STRUCTURAL INSPECTION

NEW HALL BARN, RIBCHESTER

STANTON ANDREWS ARCHITECTS

August 2015
Project No P2531

Photo 40 –Bulging Left-Hand Gable Wall

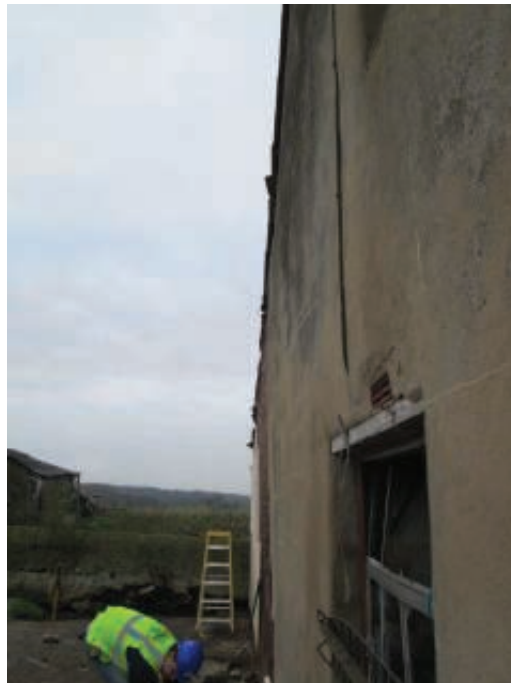
- The slating on the main barn and most of the shippon is good, reflecting the fact that they have recently been re-slatted. The roof over the outhouses on the right-hand side is poor.
- The front wall of the barn shows the significant outward lean at the left-hand corner as noted internally (**photo 34**). The wall leans inward at the main entrance door (**photo 35**).
- The right-hand gable wall of the barn is reasonably straight and vertical. There is some cracking where the rear outbuilding joins the main barn (**photo 36**).
- The rear wall of the shippon is reasonably straight and vertical (**photo 37**). The timber lintels over the windows have decayed (**photo 38**).
- The gable wall of the shippon has been partially demolished and the gap closed with plywood sheeting (**photo 37**). A gap has opened where the brick gable wall of the shippon joins the main barn (**photo 39**).

The front wall of the barn leans out significantly at the left-hand corner. This area should be re-built (see marked-up plans in Appendix B), or otherwise stabilised with new steel posts or framing. The left-hand gable wall is distorted, cracked and bulging near the in-filled first floor window. This area should be re-built (see Appendix B). The right-hand gable wall is reasonably straight and vertical. The architectural proposals show that a large part of this wall will be removed over its full height. A rigid steel frame will be needed to support the roof and to give overall lateral stability to the barn. The rear wall of the barn is reasonably straight and vertical.

Drawing Title
Existing Floor Plans

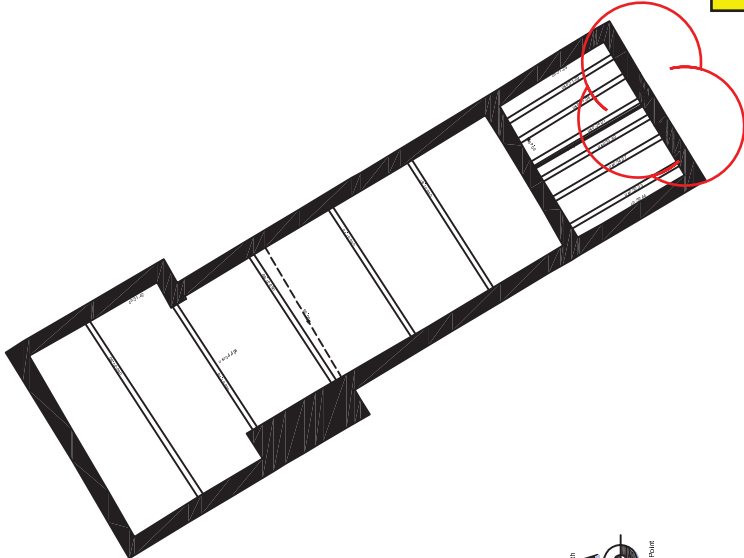
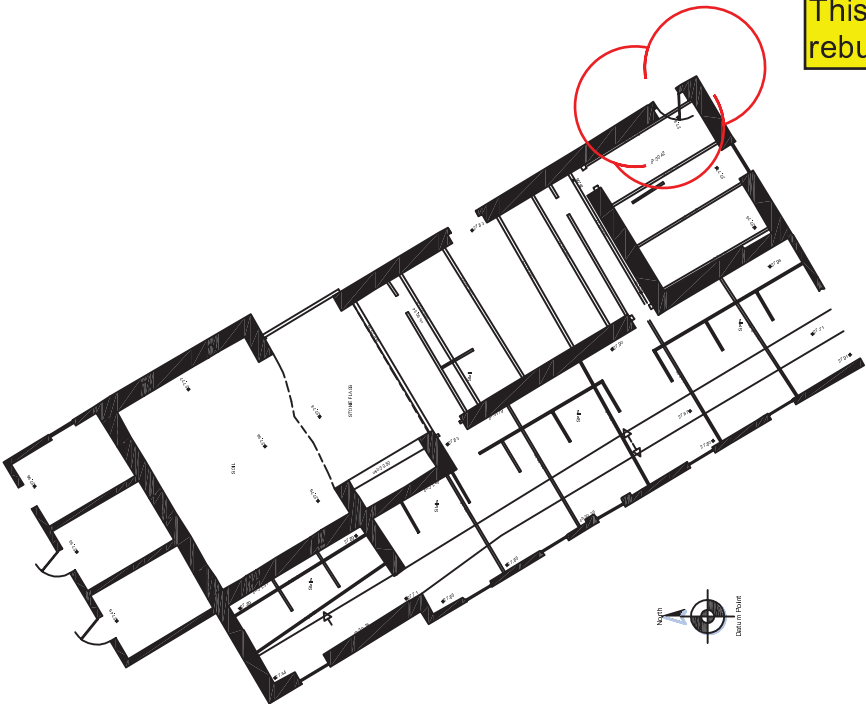
This area of wall to be rebuilt

This area of wall to be rebuilt

South East Elevation

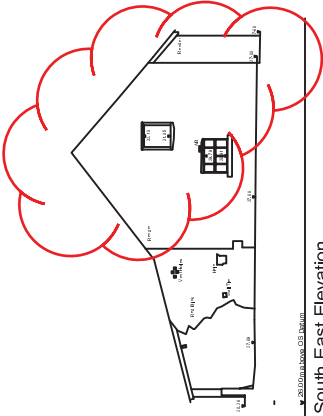
This area to be rebuilt

North East Elevation

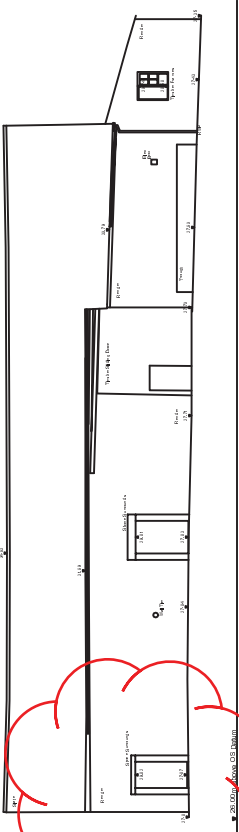
This area to be rebuilt
